FINAL PLAT OF
"DOWNS' COUNTRY ESTATES"
SEDGWICK COUNTY, KANSAS
IN THE SE 1/4 OF SECTION 17, T28S, R2E OF THE 6TH P.M.

RE: SUB 2000-84 -- Final Plat of DOWNS' COUNTRY ESTATES ADDITION

RE: SUB 2000-84 -- Final Plat of DOWNS' COUNTRY ESTATES ADDITION

CASE NUMBER: SUB 2000-84 – DOWNS COUNTRY ESTATES

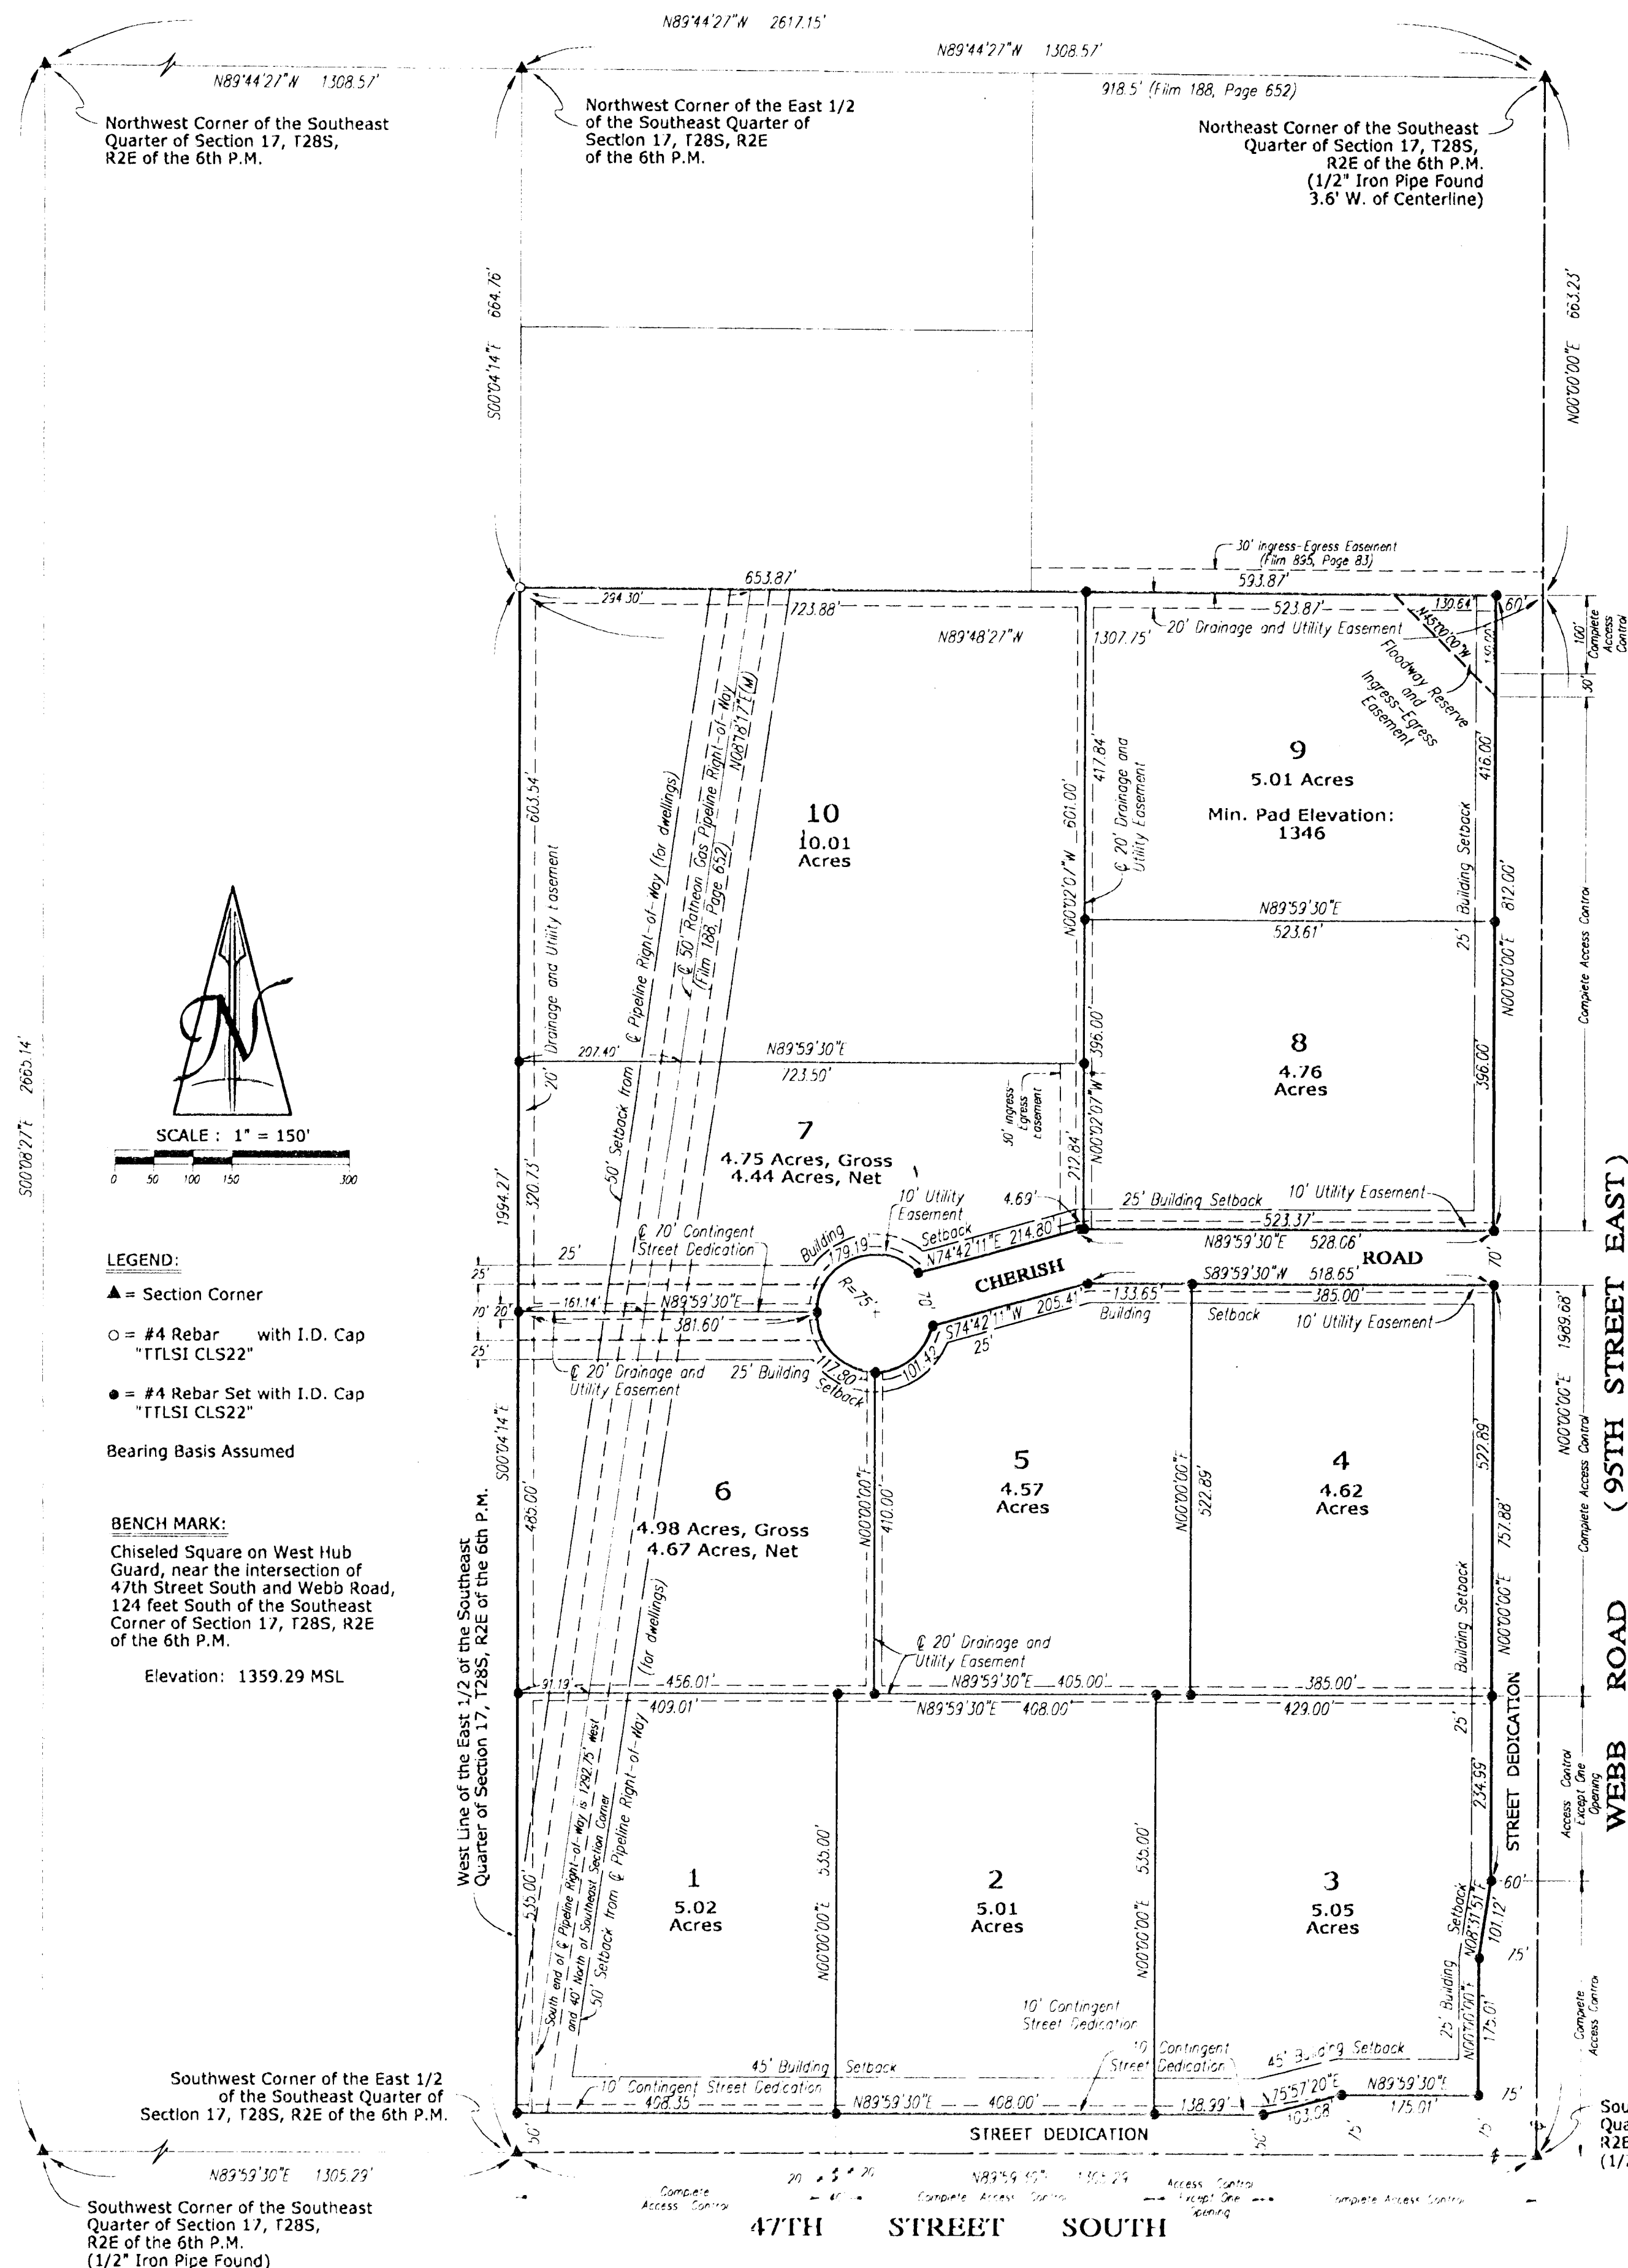
- C. County Engineering needs to comment on the status of the applicant's drainage plan. The drainage plan is approved. The minimum pad elevation for Lot 9 should be revised to read "1346".

- D. The final plat shall reference the access controls in the plat's text. The Subdivision Committee approved a shared opening between Lots 1 and 2, which shall be 40-feet wide. Lots 4 and 8 shall have access from the internal street. Lot 10 shall have access through a 20-ft private road extending through Lot 9 or Lot 7.

- I. County Engineering has required a 10-ft contingent right-of-way along 47th St. South.
- J. The applicant shall submit a copy of the instrument which establishes the pipeline easements on the property, which verifies that the easements shown are sufficient and that utilities may be located adjacent to and within the easements.

- K. The applicant's agent shall determine any setback requirements for the pipelines by researching the text of the pipeline agreements. If a setback from the pipeline easements is provided for in the pipeline easement agreements, it shall be indicated on the face of the plat.

- L. The signature line for the County Clerk needs to be revised to reference "Don Brace".
- M. The signature line for the MAPC Chairman needs to be revised to reference "Christopher S. Carraher".

- N. The signature line for the County Commissioners Chairman needs to be revised to reference "Thomas G. Winters".
- O. The applicant is reminded that a platting binder is required with the final plat. Approval of this plat will be subject to submittal of this binder and any relevant conditions found by such a review.

- P. The platator's text shall include language that a drainage plan has been developed for the plat and that all drainage easements, rights-of-way, or reserves shall remain at established grades or as modified with the approval of the applicable City or County Engineer, and unobstructed to allow for the conveyance of stormwater.

- X. The representatives from the utility companies should be prepared to comment on the need for any additional utility easements to be platted on this property. KGE has requested additional easements.
